# Work Order ID 107715

Item Name: Fwd Crosstube - High

| DRAWING NO.<br>D212-664-141 | TITLE<br>XTUBE ASSY (205/212/412 HI FWD) | REV. D               | DART AEROSPACE LTD<br>ENGINEERING ORDER |  | D.E.O. NO.<br>D212-664-141-D-1 | SHEET NO.<br>SHEET 1 OF 2 | SCALE<br>NTS |

**D212-664-141/-141B  
ASSEMBLY DETAIL**

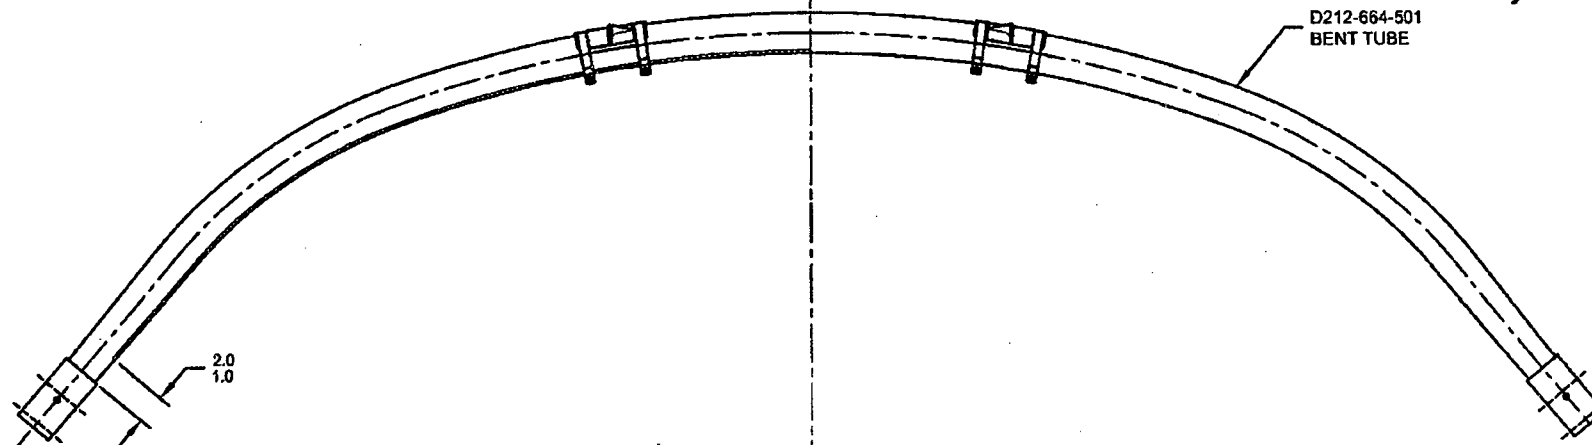
ADD AN INSPECTION WINDOW TO UNDERSIDE OF CROSSTUBE.

IS:

WAS:

- 2) FINISH: CHEMICAL CONVERSION COAT PER DART QSI 005 4.1  
PRIME INSIDE AND OUTSIDE PER DART QSI 005 4.2  
MASK UNDERSIDE OF CROSSTUBE AS SHOWN (HATCHED AREA) AND  
PAINT OUTSIDE PER DART QSI 005 4.2  
REMOVE MASKING AND APPLY CLEAR COAT

MASK AREA PRIOR TO PAINTING.  
REMOVE MASKING AFTER PAINT  
AND APPLY CLEAR COAT
